**DOCKET**  
**09-AFC-9**

RE: Ridgecrest Solar Power Project (RSPP), Docket No. 09-AFC-9, Responses to CEC Data Requests for Biological Resources (DR 61) and Land Use/Recreation/Wilderness (DR 257-261)

**RIDGECREST SOLAR POWER PROJECT (09-AFC-9)**  
**CEC STAFF DATA REQUEST NUMBER 61**

**RIDGECREST SOLAR POWER PROJECT (09-AFC-9)  
CEC STAFF DATA REQUEST NUMBERS 257 - 261**

**Figure DR-LURW-257-1  
 WEMO Designated Routes**

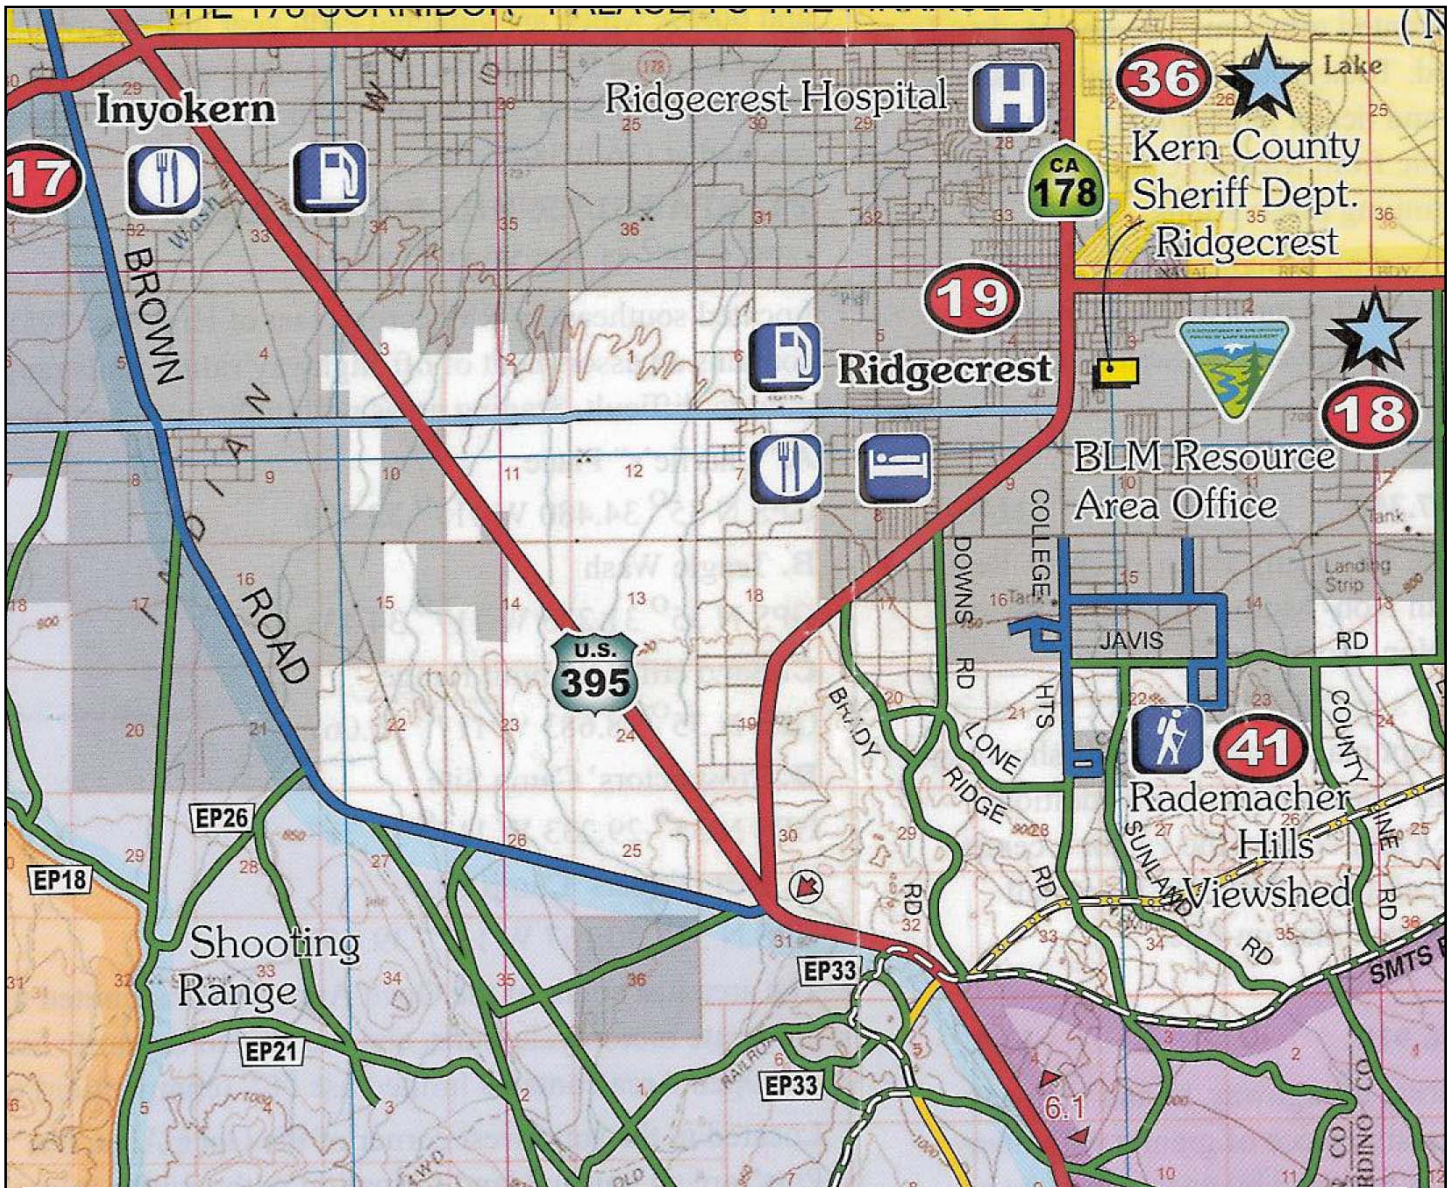
Please provide a discussion of existing trails into and through the proposed Bureau of Land Management (BLM) right-of-way (ROW) area and proposed Project site, supported by on-site surveys. Identify potential impacts to existing recreational opportunities and established sites.

Please provide figure(s)/table(s) depicting the location(s), type, and frequency of use, general route conditions, destination(s), and current BLM designation (if applicable) for existing OHV and other established access trails into and through the proposed Project ROW area and Project site. Site configuration should represent the amended Project boundaries, as presented at the January 5–6 workshops. Include information for Project alternatives, if different from the preferred Project alternative. Mapping of trail routes should reflect GPS ground survey findings and on-site visual observations.

Figure DR-LURW-257-1 WEMO-Designated Routes depicts designated OHV routes in the vicinity of the Project site. As described in the Section 5.7 Land Use of the Application for Certification (AFC), those routes are from 1985-1987 designations, and will be updated by the El Paso Collaborative Access Planning Area (El Paso CAPA). During the January 5-6, 2010 Energy Commission/BLM Workshops, Scoping, and Information Meetings, the BLM indicated that these designated routes have not been field-verified. Thus, the Applicant has delineated routes based on aerial imagery and field verification. Locations of existing open designated routes within the vicinity of the Project site and the findings are presented below.

Please see Figures DR-LURW-257-1, DR-LURW-257-2 and DR-LURW-257-3, and Table DR-LURW-258 below. Use levels of designated routes within the Project ROW are based on one day of field observations. Use levels have been ranked from low to high. Use levels were determined by observing the level of soil compaction, soil erosion, surface material (asphalt versus dirt) and condition of the vegetation on and adjacent to the route. The actual number of OHV vehicles using each of the routes is unknown.

**Figure DR-LURW-257-3  
Existing OHV Routes  
and Connectivity Options**

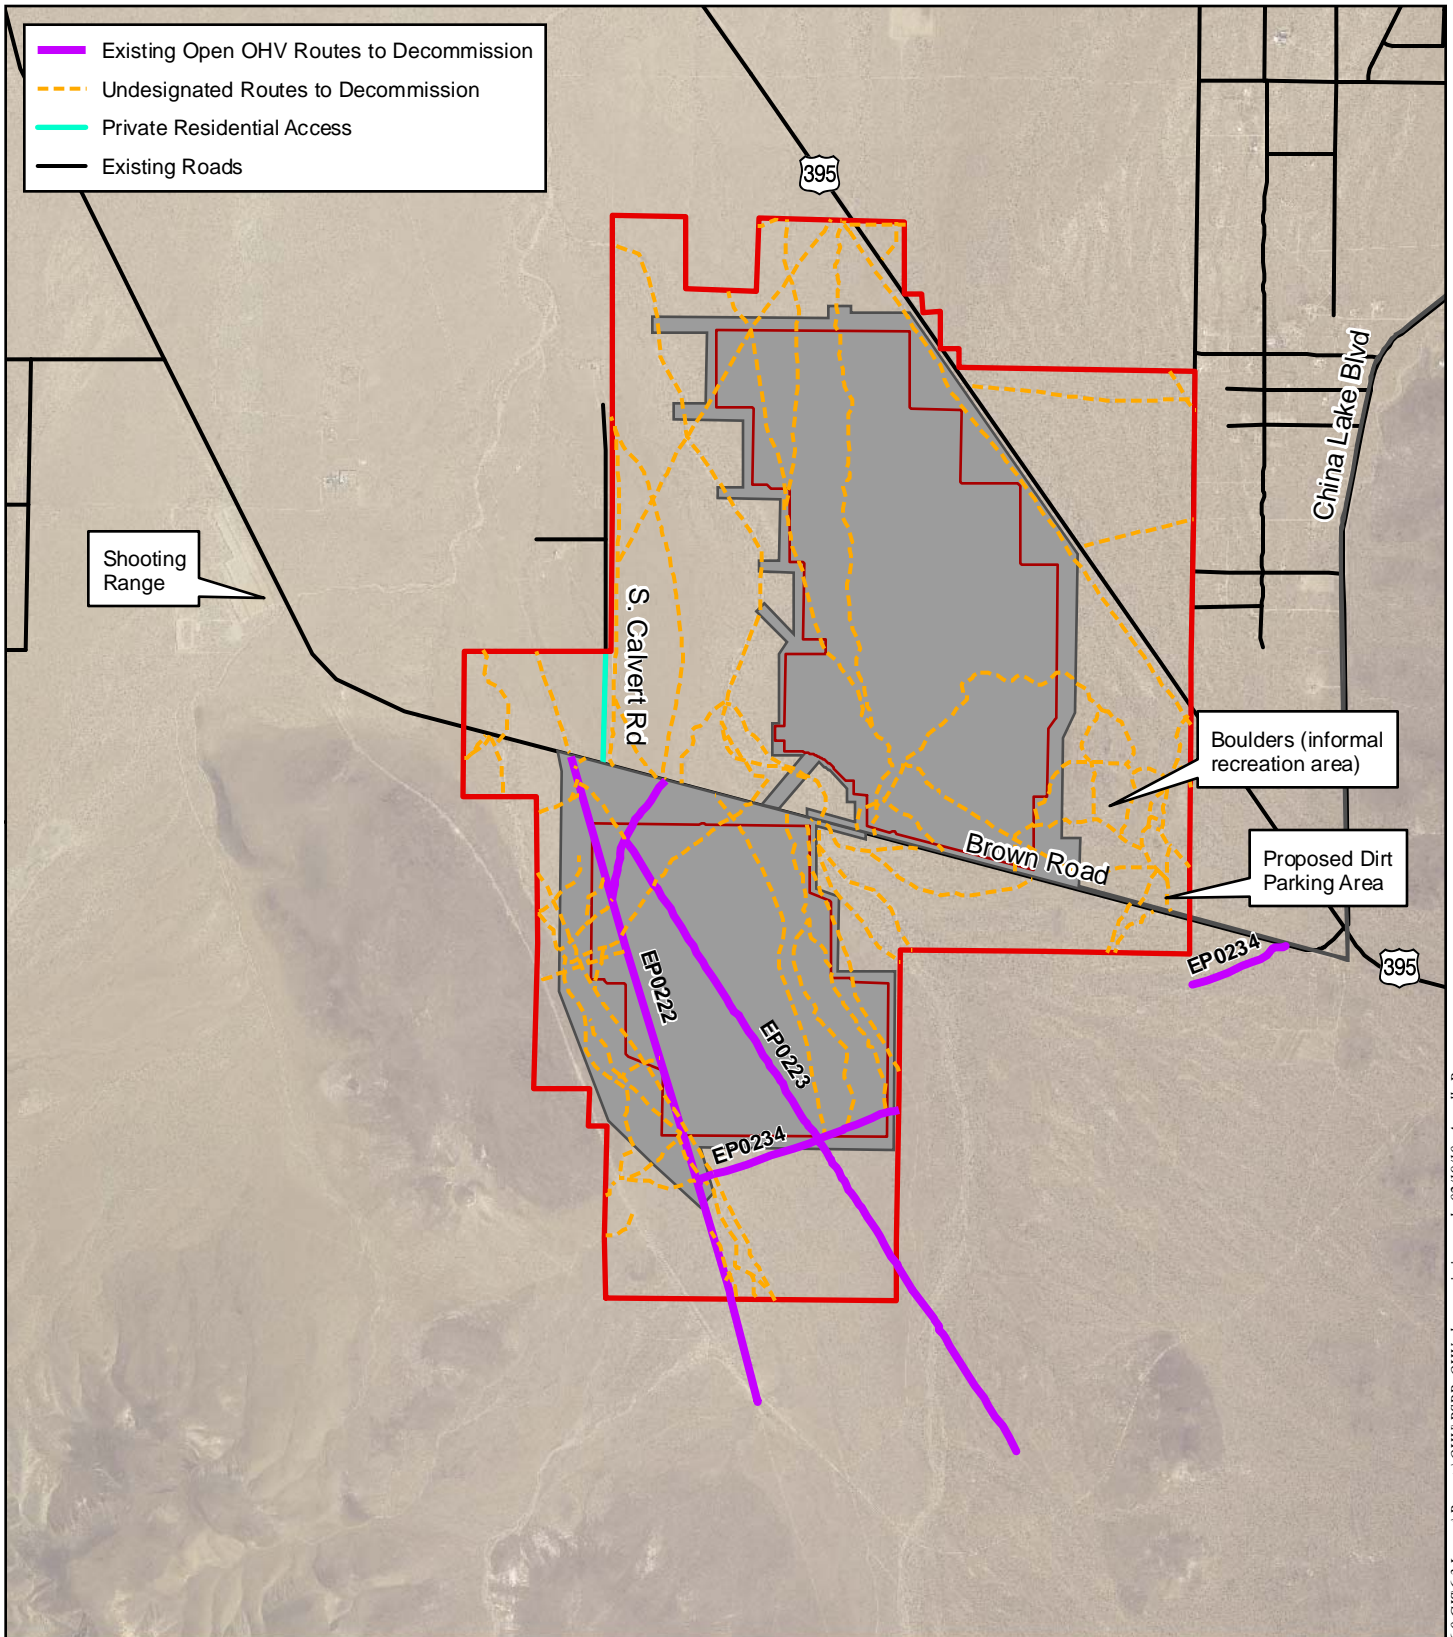
Please identify and discuss recommended reroutes and/or alternative routes or sites to mitigate loss of access and recreational value. Evaluate alternatives for comparability to existing facilities and availability and consistency with the BLM Route Designation Minimization criteria. Alternative routing should not closely parallel Project boundaries or join existing access trails in a manner that would encourage users to follow existing access trails to the closure point, skirt the Project fence line (resulting in a proliferation of unofficial trails), or rejoin the original route on the other side of the Project.

Table DR-LURW-258 provides details regarding the routes that are located within the Project ROW (see Figure DR-LURW-257-3 – Existing OHV Routes). The routes that are described within Table DR-LURW-258 are those that are shown on the Friends of Jawbone Map and were verified during the AECOM field survey. The five WEMO-existing open designated OHV routes that intersect the Project ROW have an approximate total length of 5.1 miles within the Project ROW. WEMO maps show three designated routes north of Brown road (no route numbers assigned) within the Project ROW. While these routes can still be found on the ground, there are no public maps or signs on the routes indicating that these are designated routes. Approximately 1.9 miles of these routes are graded electrical transmission line maintenance roads. The other 3.2 miles are jeep trails (routes). A short section of designated Route EP021 (EP421 on WEMO map) enters the south edge of the Project ROW and would remain as a designated route to provide east-west OHV connectivity. One of the designated routes (EP 0234) leaves the east side of the Project ROW and passes through private property to the east of the Project ROW and then connects to the south side of Brown Road. South Calvert Road is a 1.2-mile road on the western edge of the ROW that provides access to private property just north of Brown Road (Figure DR-LURW-257-1). There are approximately 39.25 miles of other roads within the Project ROW that are not open (i.e. not designated) for OHV use. These other roads provide utility access or are remnants of roads created before OHV routes were designated by BLM. All routes in the Project ROW have a natural sandy to clay road base.

Existing designated routes in the Project ROW provide access from Brown Road to OHV routes to the south (see Figures DR-LURW-257-1, DR-LURW-257-2, DR-LURW-257-3 and DR-LURW-259, and Table DR-LURW-259). In the vicinity of the Project site, there are no existing open OHV routes north of Brown Road, and, therefore, it would not be feasible to make OHV route connections to the north without designating new routes. OHV routes are needed on the west and east sides of the Project ROW that provide connections from Brown Road to the south. For the most part, this can be accomplished using existing designated routes. One existing road that would provide OHV connectivity is the existing designated Wiknich Road – EP26 (EP0218 on WEMO map). This road is asphalt and thus would require a parallel ATV/motorcycle trail on the east edge of the road ROW. There is private land on both sides of Wiknich Road near Brown Road and there is a shooting range on the west side of the road near Brown Road. Another existing designated route would be EP21 road (EP0219 and EP0421 on WEMO map), which would provide an east/west route south of the Project ROW. EP21 connects to Wiknich Road - EP26 (EP0218 on WEMO map). EP21 road then connects to EP33 (EP0238 on WEMO map) road, which continues east to the Spangler OHV area. A 1-mile-long existing designated OHV route (shown as designated route EP0237 on the WEMO map) would connect Route EP33 (EP0238 on WEMO map) to the intersection of Brown Road, U.S. Highway 395, and South China Boulevard. The existing area south of the intersection of U.S. Highway 395, Brown Road, and South China Boulevard can serve as an access point or parking area for the OHV routes.

**Figure DR-LURW-259  
Route Decommissioning**

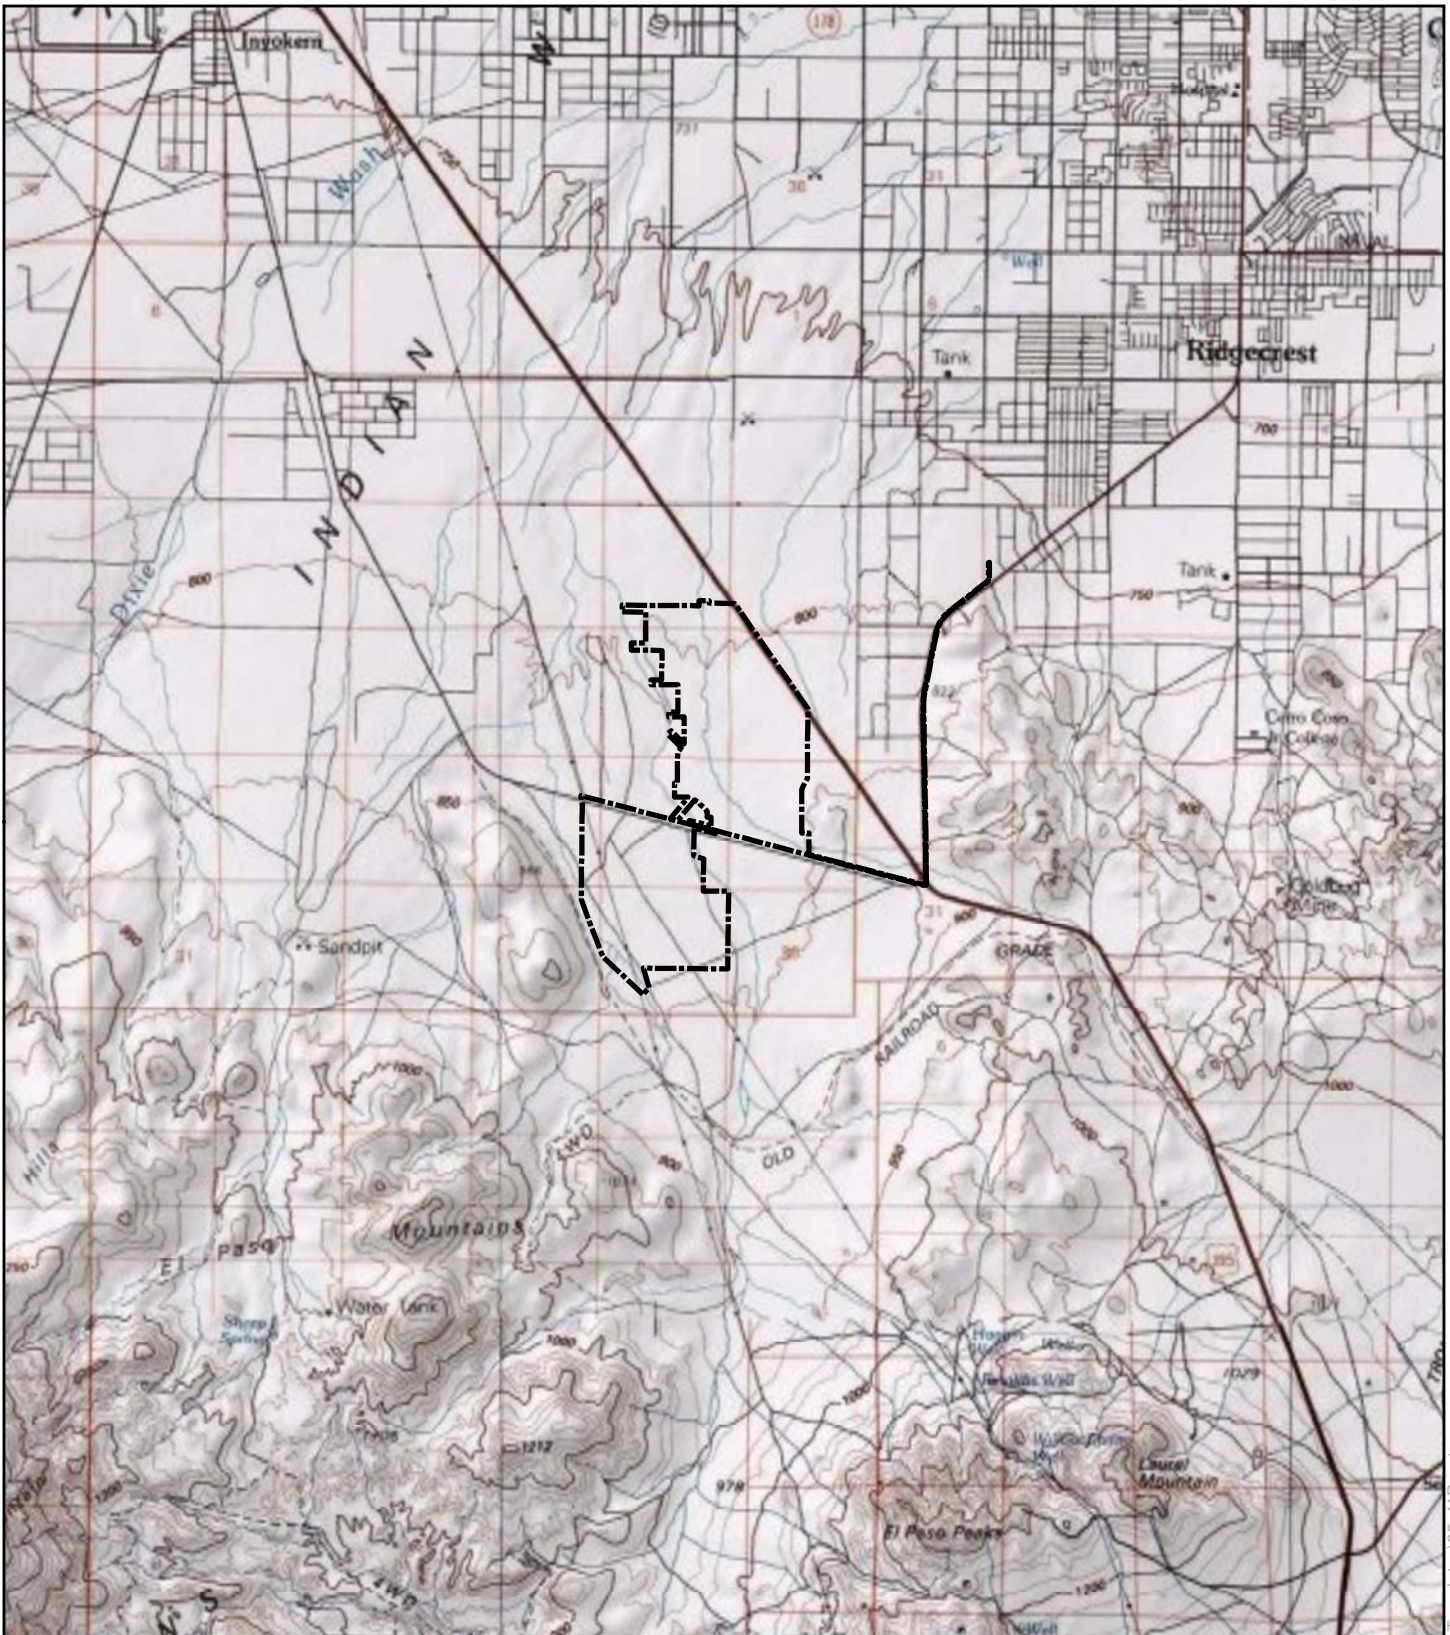
Several of the existing routes would dead-end at the Project security fence once the Project is constructed. Please recommend measures to remediate terrain along decommissioned routes from the rerouted portion of the route to fence line, or from the fence line to point of access. Provide justification for any areas where remediation would not occur.

The existing designated route that extends from the intersection of Brown Road and U.S. Highway 395 to the southwest and into the Project ROW is recommended to be closed to public use. This route traverses private land to the east of the Project ROW. An alternative route can be provided to the south to connect to designated routes there. An existing designated OHV route (EP0237) due south from the intersection of Brown Road and U.S. Highway 395 would provide a better recreation experience and provide good connectivity.

As elaborated in the response to DR-LURW-257, the designated routes in the Project ROW provide a relatively low quality OHV experience. Nonetheless, to mitigate for the closure of designated OHV routes in and around the Project ROW, the Applicant would work with the BLM to provide OHV connectivity around the Project ROW with connections to other OHV routes. The existing and proposed designated routes that would be open for OHV use in the future would not come close to the Project ROW, and thus the public would not have a need to approach the Project fencing. Responses to the next question DR-LURW-260 provide recommendations for methods to decommission routes.
